MEETING: REGULAR MEETING OF THE PLAN COMMISSION
DATE & TIME: Monday, August 26, 2024 at 6:30 PM
LOCATION: Germantown Village Hall Board Room
N112 W17001 Mequon Road

- C. MSA Professional Services, Inc. Agent for CrossWay Church Property Owner, W156 N10041 Pilgrim Road. Site Plan Review - Parking lot Expansion & Driveway Reconstruction. (ACTION)

Brian Kehrli, MSA Professional Services, and Ben Cartland, agents for CrossWay Church, property owner, are requesting approval of site development & building plans for a 107-stall parking lot expansion, new driveway connection to Santa Fe/Council Bluffs Drive, and reconstructed driveway entrance on Pilgrim Road for the existing church facility located at W156 N10041 Pilgrim Road.

TITLE SHEET

DRIVEWAY DETAIL - SANTA FE DR

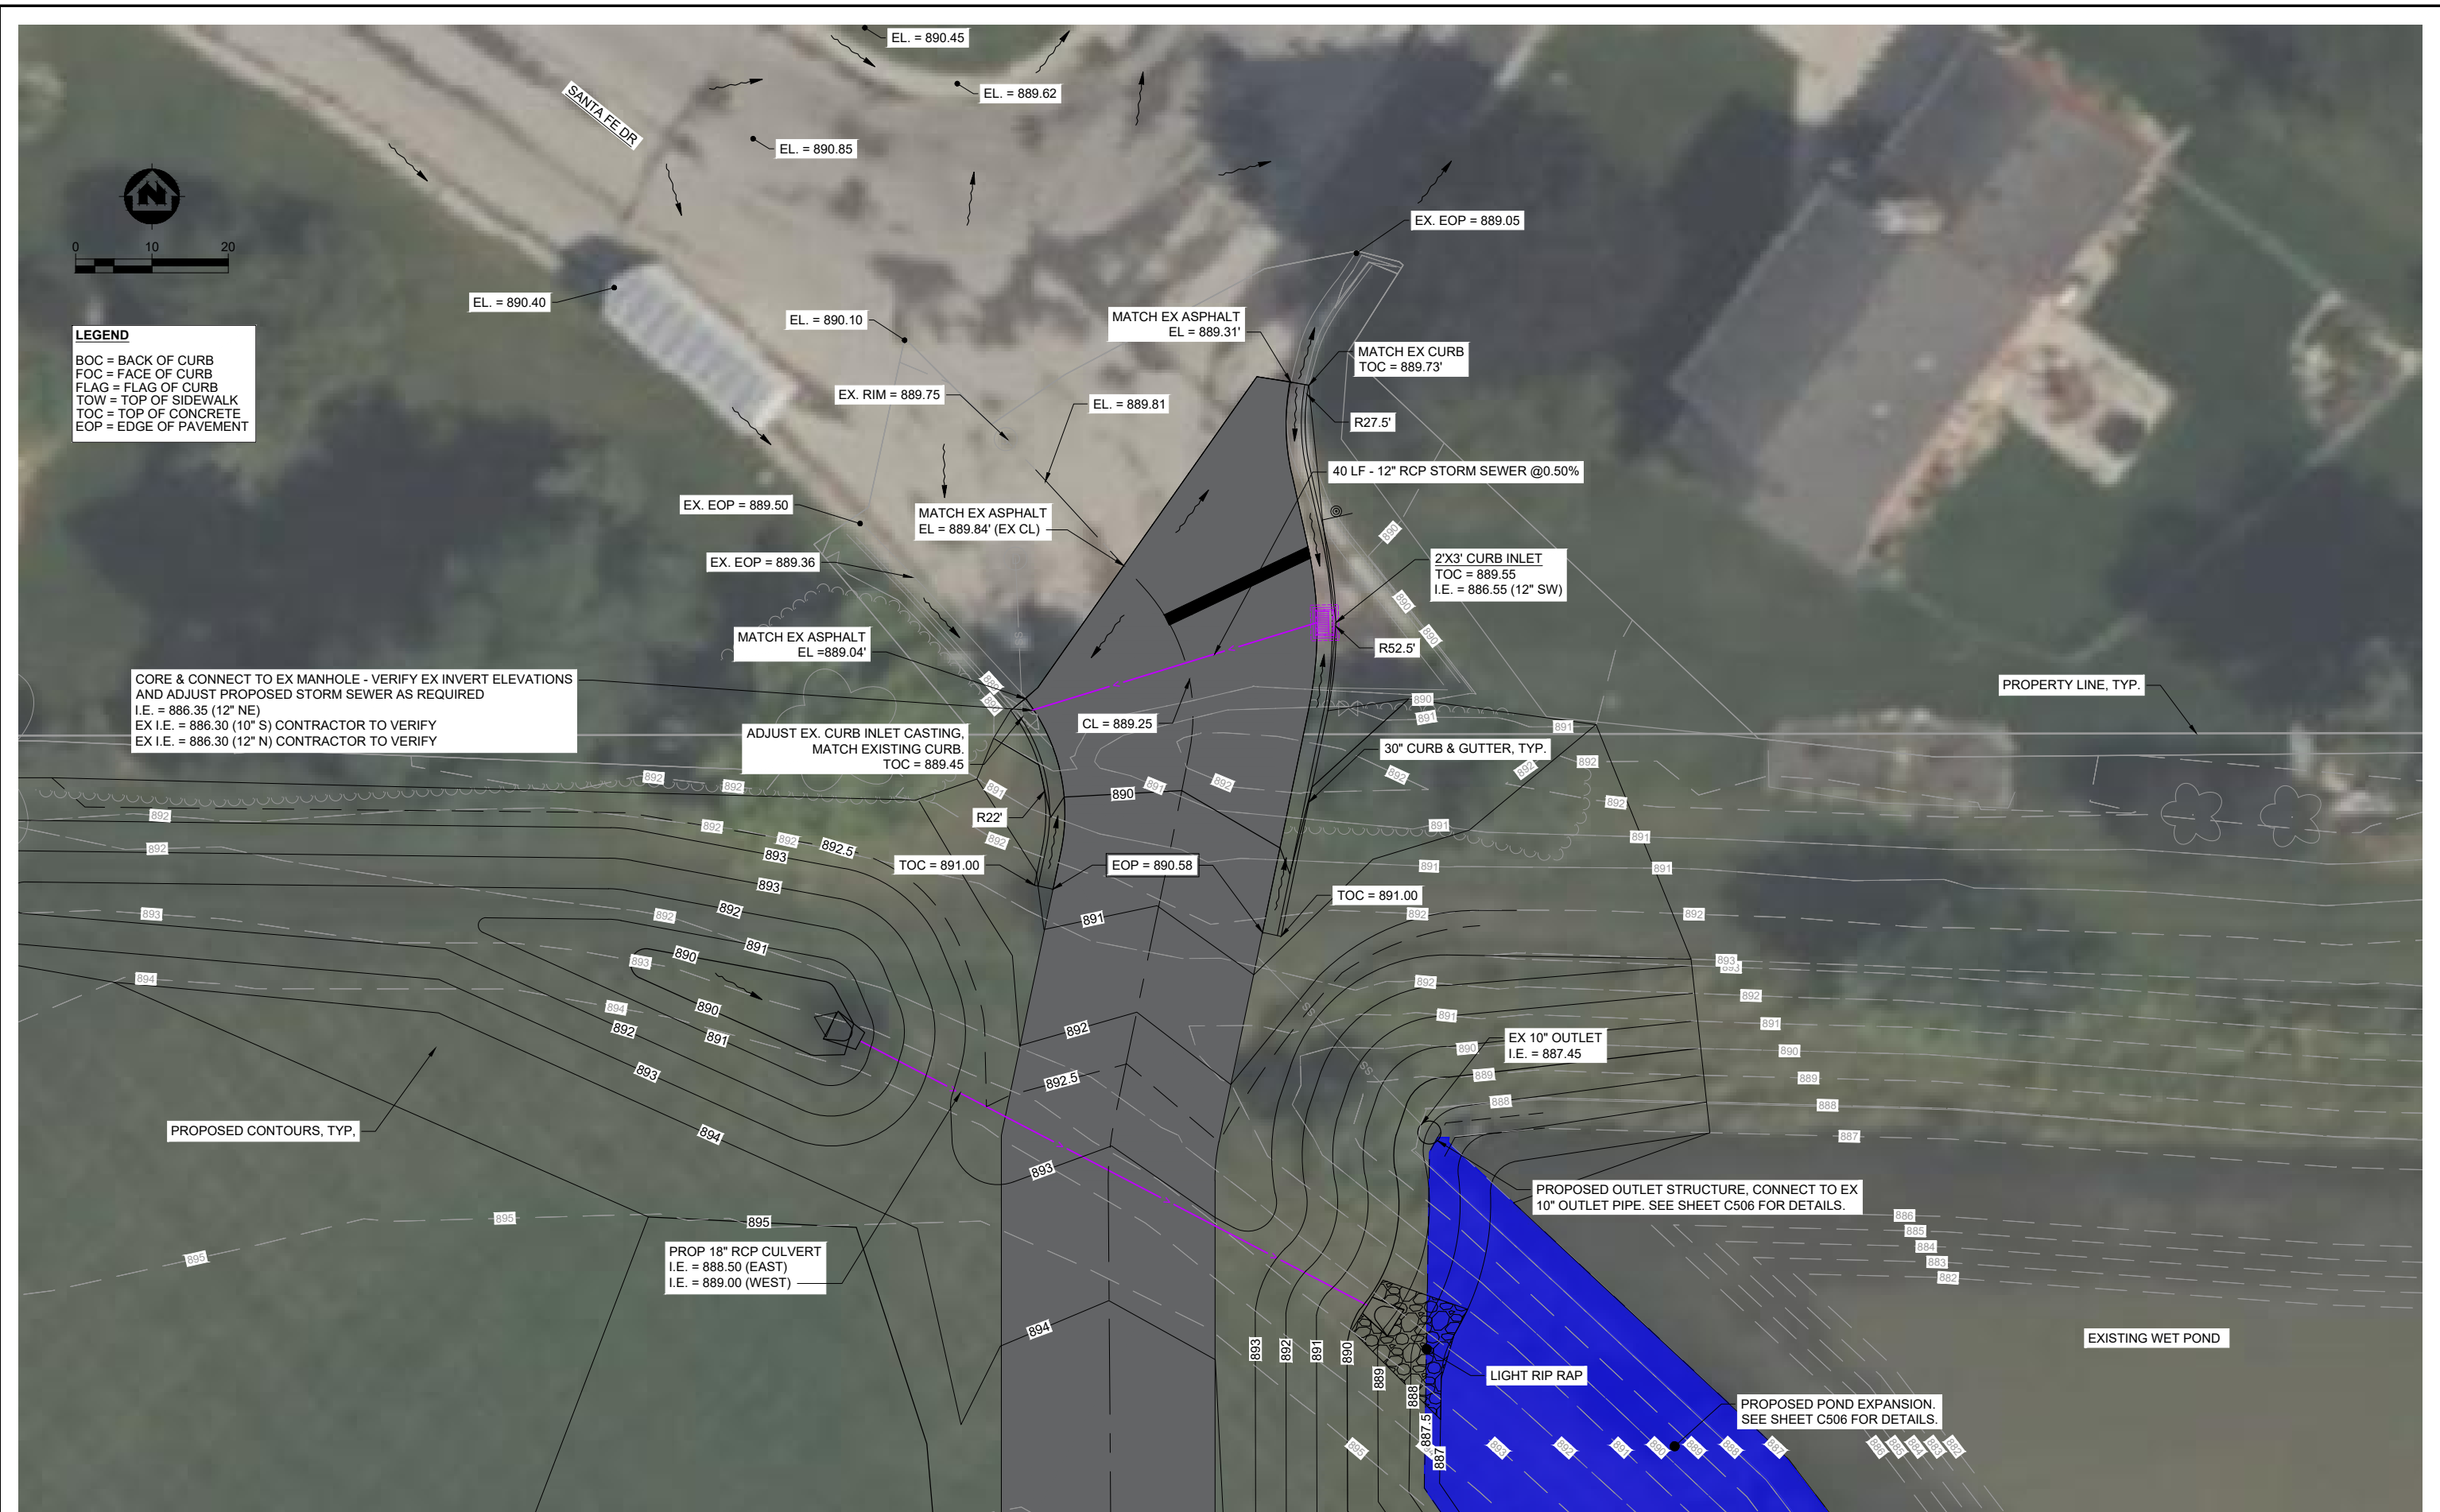
6. Provide additional spot elevations and existing topo around the Santa Fe Drive intersection. Sheet C508 has numerous spot elevations and all the topo that we shot. A few more spot elevations were added in the intersection outside of the removal limits for reference. What else is desired to be shown?

PROPOSED LANDSCAPING PLAN

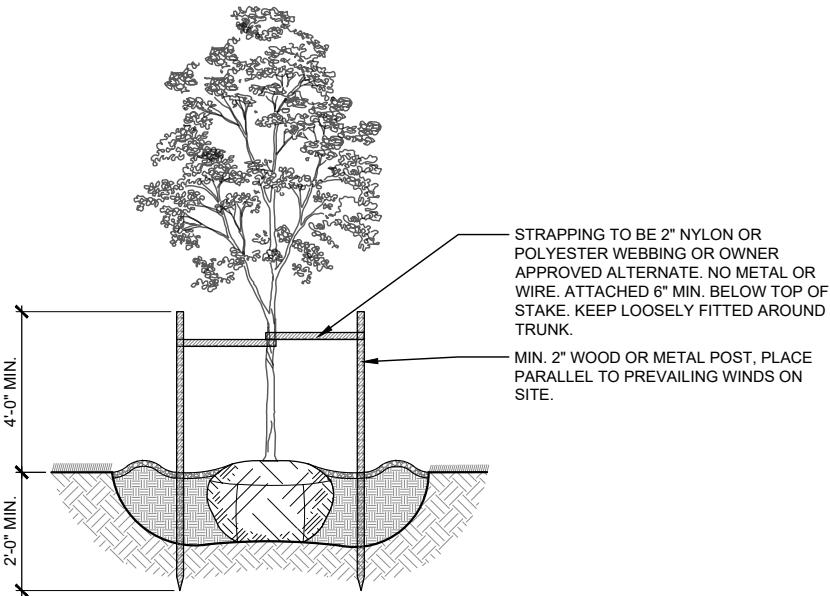
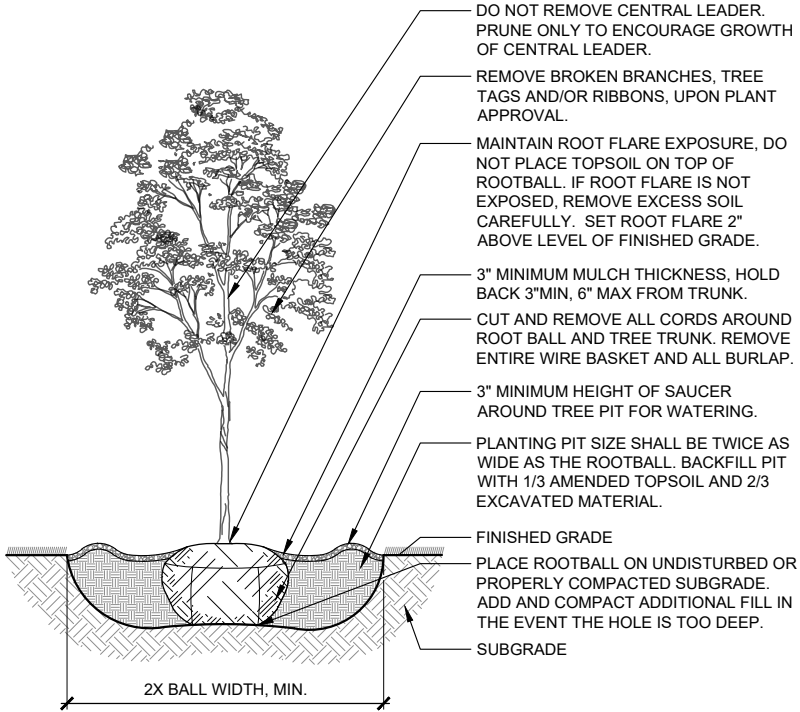
proposed. As shown in the landscape plan (Sheet L201) curbed islands with one (1) deciduous tree per island along with a variety of shrubs and mulch are proposed in the two new parking areas. Overall, one (1) new deciduous tree per 10 parking stalls is proposed (12 trees total). A perimeter buffer is proposed west of and around the new parking area and driveway to Santa Fe/Council Bluffs Drive along the west property line comprised of plantings that include a variety of deciduous and evergreen trees (see Sheet L201).

- a. July 2, 2024 memo from Kevin Driscoll, PE, Village Engineer
 4. With respect to the proposed evergreen trees shown in the landscape plan dated 8-23-2024, the Church shall select and install a different tree species than Austrian Pine. Acceptable alternatives are listed below. The Church should coordinate any plan revisions with the Village Forester prior to installation:

2. What type & quantity of trees & shrubs are being added within and around the perimeter of the new parking area?
 - a. **Per sheet L201, Landscaping plan associated with the parking lot project, there will be 1 tree planted for each 10 stalls added. There are 107 added parking stalls so 11 trees are required per the ordinance. 12 trees are shown on the sheet L201 to be added as one existing tree will be removed and replaced.**
